FOR THE MEETING OF: April 15, 2021
AGENDA ITEM: 5.a

TO: Historic Landmarks Commission

CASE NO.: Historic Design Review Case No. HIS21-02

APPLICATION SUMMARY: A proposal to construct a new two story house.

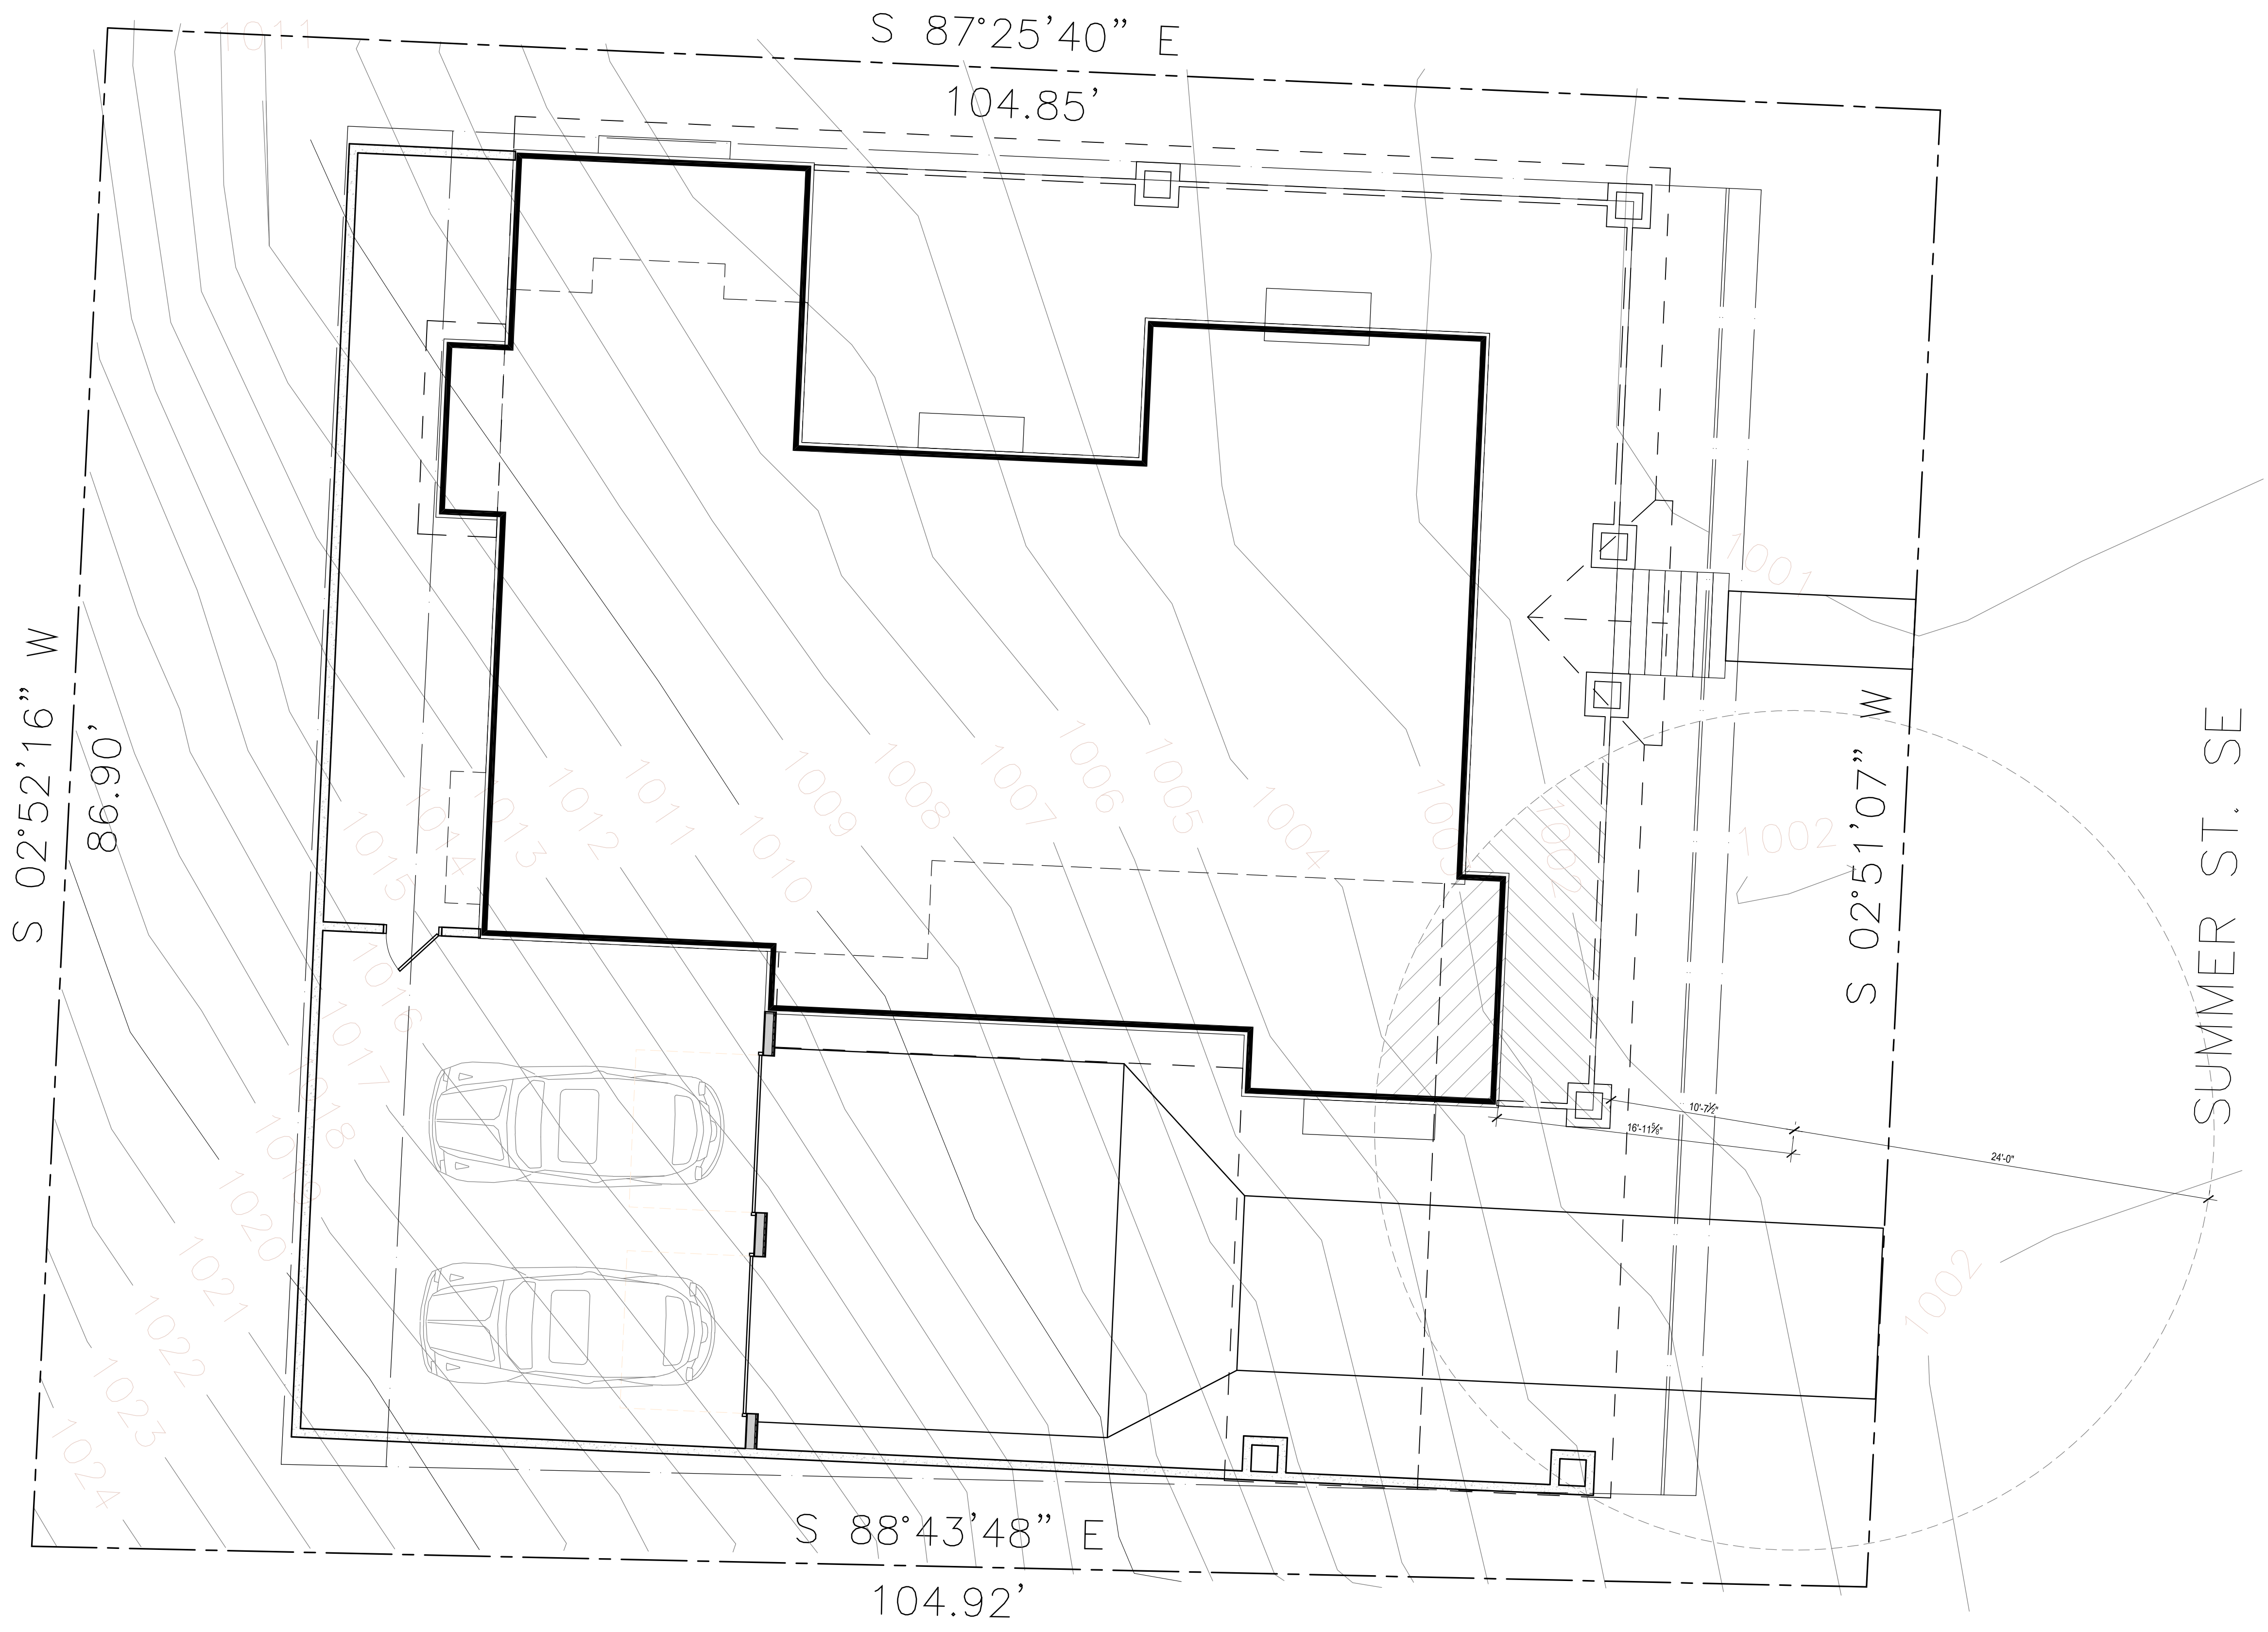
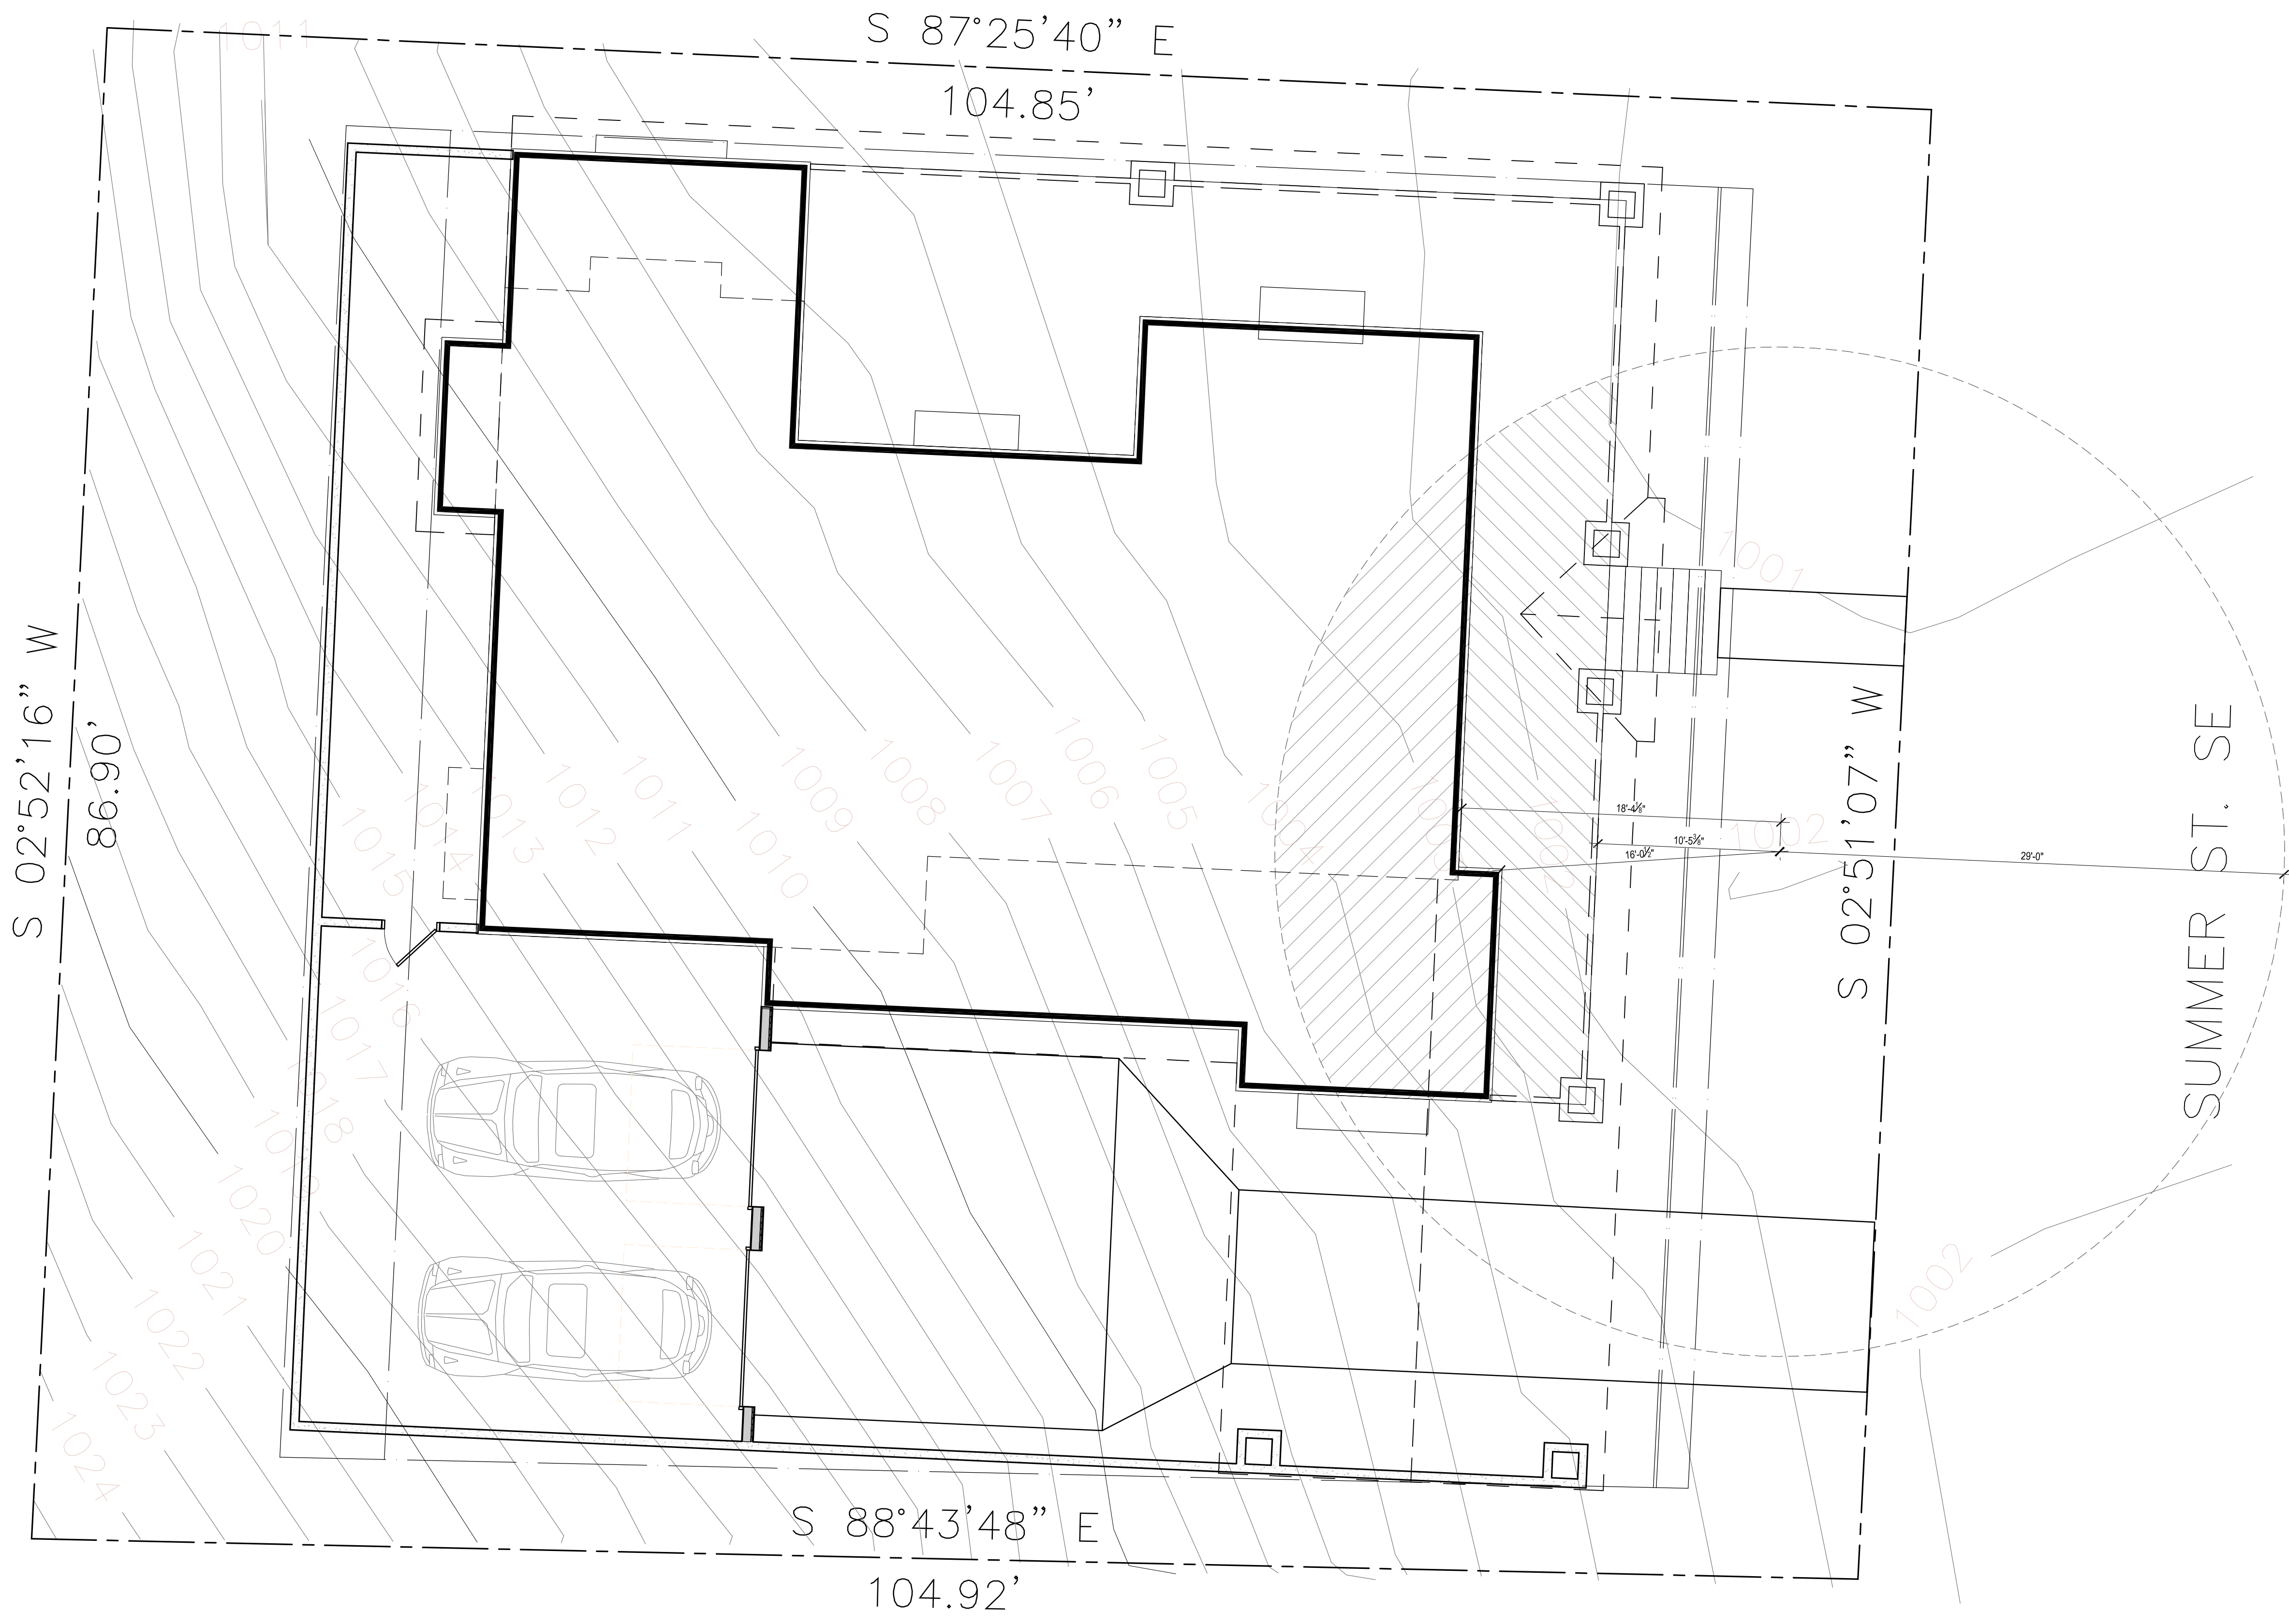
Finding: The applicant has made a concerted effort to ensure that the proposed house is designed to fit on this steeply sloped lot in a way that allows it to fit within the existing neighborhood. There are two oak trees proposed for retention located on the eastern portion of the site abutting Summer Street. The applicant is proposing

to install the driveway within the dripline of these trees. The grade of this driveway will be two feet above the existing grade, in order to meet the existing grade at Summer Street SE, therefore no additional excavation will be required to install the driveway, minimizing the adverse effect to these trees. However, the installation of the porch foundation on the eastern end of the house is also within the dripline of these trees and has the potential to impact the long-term health of these trees. In order to better meet this criterion and ensure that these oak trees have a better chance of survival, staff recommends that the HLC adopt the following Condition of Approval:

Condition 1: In order to reduce the potential adverse effect of the construction on the existing oak trees proposed for retention on the eastern portion property, the applicant shall utilize a pier style foundation under the eastern porch instead of a traditional foundation wall or slab so the building pressure is limited to these pier locations.
